## **Revised Nevada Division of Environmental Protection BART Determination Review of NV Energy's Reid Gardner Generating Station Units 1, 2 and 3**

NDEP's review of NVE's October 3, 2008 BART determination report for Reid Gardner resulted in revisions to all of the source's BART determinations except the control technologies

**FIGURE 1**

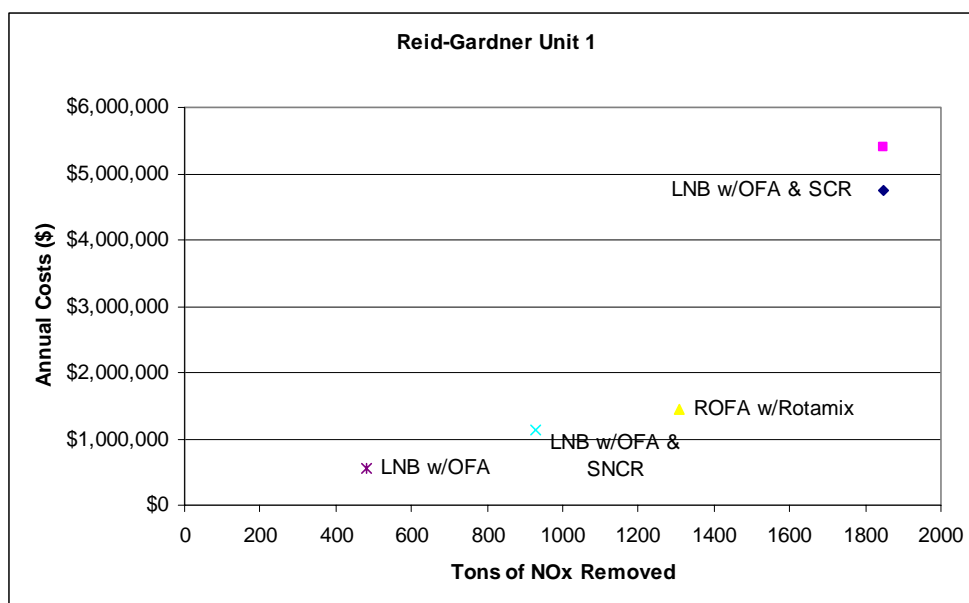
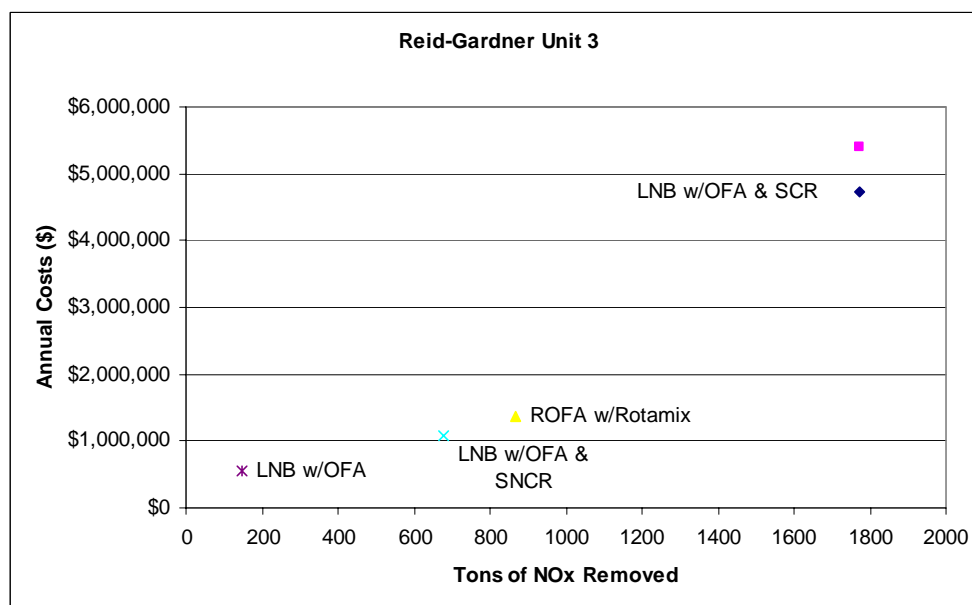
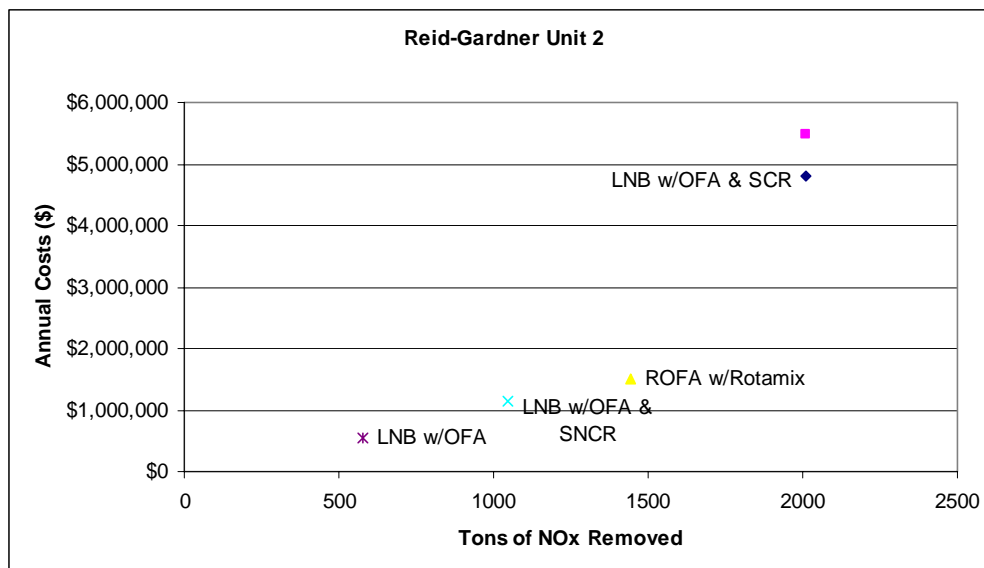
NDEP specifically reviewed the cost per ton of NO<sub>x</sub> removed for each unit at Reid Gardner and determined that installation of ROFA with Rotamix for units 1 through 3 meets the BART criteria, with associated first year costs of \$1,038 to \$1,588/ton of NO<sub>x</sub> removed, depending on the unit evaluated. These values are considered cost effective. The cost data from the tables above are presented graphically in Figure 1. NDEP also concluded based on a review of the economic analysis that the \$/ton of NO<sub>x</sub> removed increased significantly for the LNB with OFA and SNCR, and ROFA with SCR technologies without correspondingly significant improvements in visibility.

NDEP concludes that for NO<sub>x</sub> the installation of ROFA with Rotamix with an emission level at 0.20 lb/MMBtu for unit 1 and unit 2, and 0.28 lb/MMBtu for unit 3, on a 12-month rolling average, is BART. NDEP has also concluded that the BART emission limit for SO<sub>2</sub> is 0.25 lb/MMBtu for all three units and the BART emission limit for PM<sub>10</sub> is 0.015 lb/MMBtu for all three units
